## VALLEY - ALUMINUM/NAIL IN MOLDING TO T-MOLDING UPDATE

Due to vendor quality issues, the aluminum trim used for years is **no longer available**. We now use a t-molding

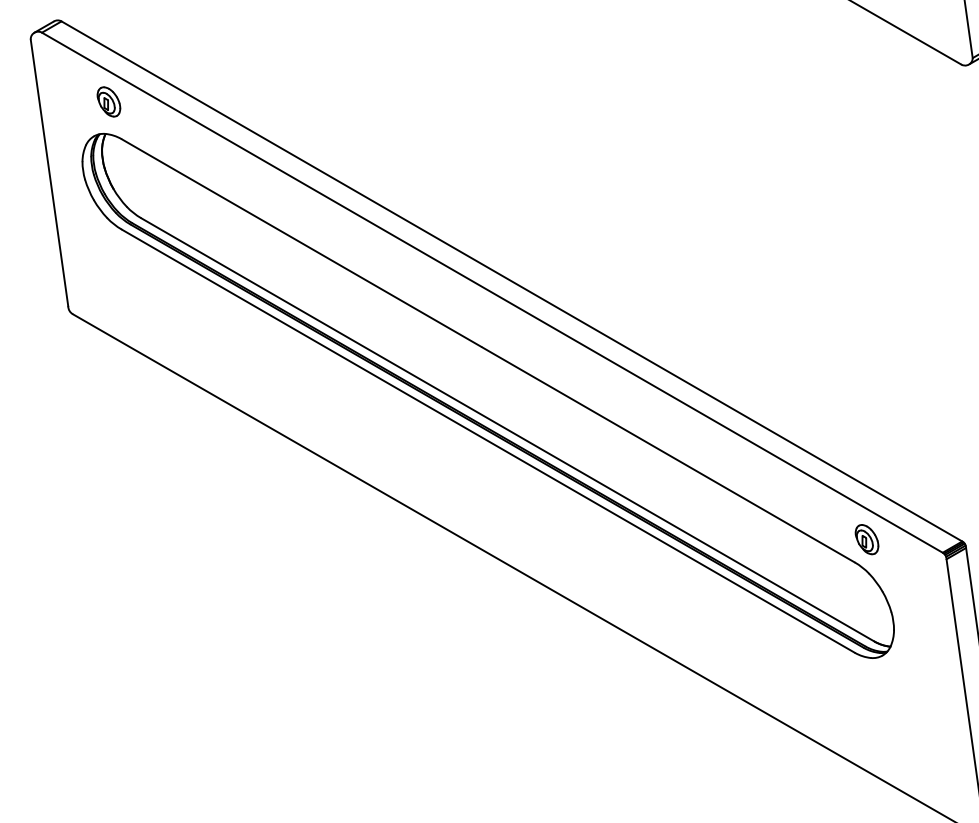
1. CAREFULLY REMOVE THE EXISTING TRIM FROM THE BALL VIEW DOOR
2. REMOVE THE (2) LOCKS FROM THE DOOR
3. PLACE DOOR ON A NON-SLIP SURFACE OR SECURELY CLAMP TO A SOLID SURFACE

6. INSERT THE REPLACEMENT MOLDING INTO SLOT BY TAPPING INTO PLACE
7. TRIM TO PROPER LENGTH
8. RE-INSTALL LOCKS, NOTING KEY ALIGNMENT

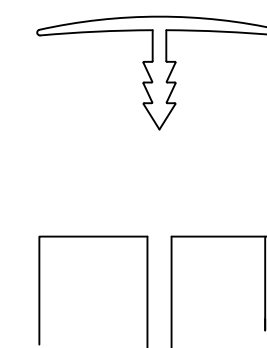
4. MAKE CERTAIN THE SLOT CUTTER IS SET TO BE CENTERED ON THE THICKNESS OF THE DOOR.

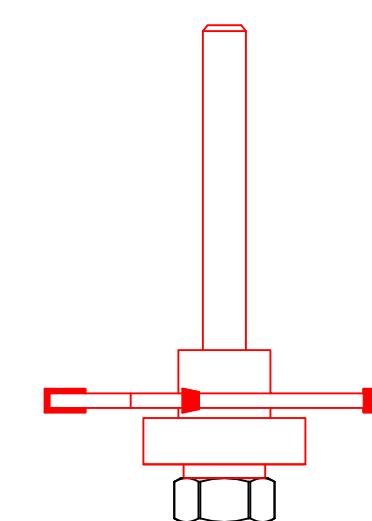
5. CAREFULLY CUT THE SLOT INTO THE DOOR

USE A 3/32 SLOT CUTTER
